# REGIONAL REVIEW NOTIFICATION

**ARC REVIEW CODE:** R2006051

**Name of Proposal:** MFT Braselton Highway Tract (DRI #3077)

TASK:  
**CONCEPTUAL  
 REZONING  
 EXHIBIT**

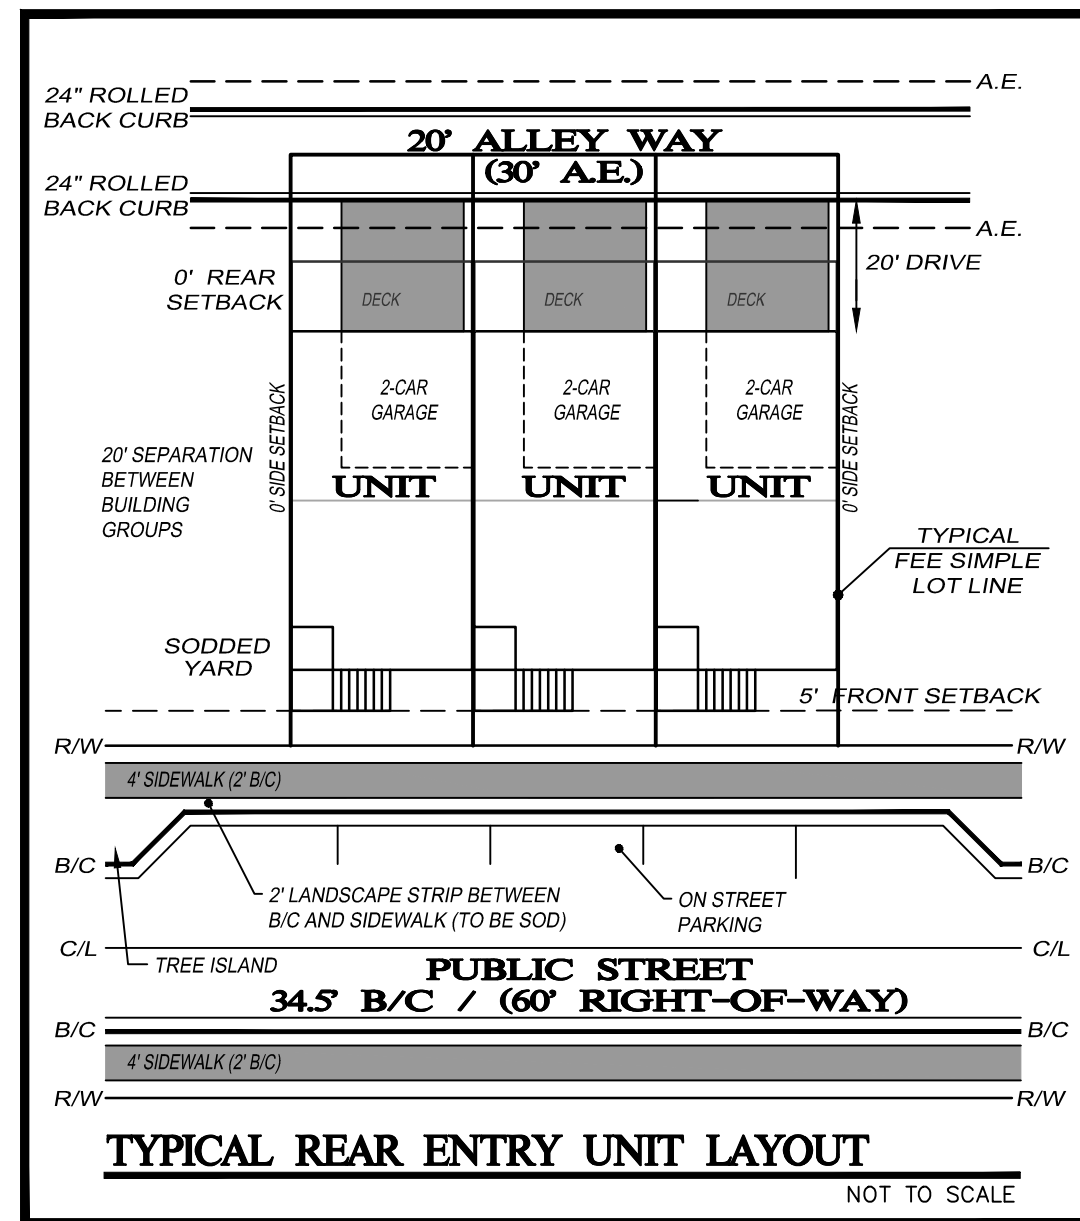
The proposed site plan as currently configured shows the commercial buildings as primarily auto-oriented, by being separated from the street and sidewalk by surface parking, and multiple drive-through restaurants on the portion fronting Braselton Highway. The buildings are surrounded by surface parking, so they also impede pedestrian connections for residents of the development and workers in the other commercial buildings. If the intent of the design recommendations in the Unified Plan are to promote a more pedestrian-oriented environment at the appropriate locations, the buildings should be re-oriented to either or both the external street and internal streets. While drive-through restaurants will always be challenging to balance with a quality pedestrian environment, it is possible to situate the parking and driveways inside the commercial cluster to reduce the conflicts. The proposed commercial outparcels at the northeastern corner of the site are also separated from both the external street and the internal street by surface parking. There appears to be ample space to orient the buildings to the street with parking behind them.

Across the entire project, closer attention needs to be paid to the pedestrian network, including sidewalk location, crosswalks, building orientation, pathways to amenities, and other changes that could reasonably improve internal walkability and reduce the number of internal vehicle trips required to access all the development's features. Additional comments from ARC's Transportation Access & Mobility Group are attached.

They note that the site plan doesn't currently show the State 25-foot Sediment and Erosion Control buffer along Duncan Creek.

Both the site plan and the USGS coverage for the project area show Duncan Creek crossing the western and northwestern portion of the property. The Gwinnett County 50-foot stream buffer and 75-foot impervious setback are shown, but the State 25-foot Sediment and Erosion Control buffer is not shown along the stream. The site plan shows a portion of a proposed trail within the 75-foot setback and several proposed lots extend into the setback. Activity within the setback that is not specifically allowed under the Gwinnett Stream Buffer Ordinance may require variances. There are no intrusions into the 50-foot buffer or the 25-foot State buffer. Any unmapped streams on the property may be subject to the County and State buffers. Any unmapped waters of the state will also be subject to the State 25-foot Sediment and Erosion Control buffer.
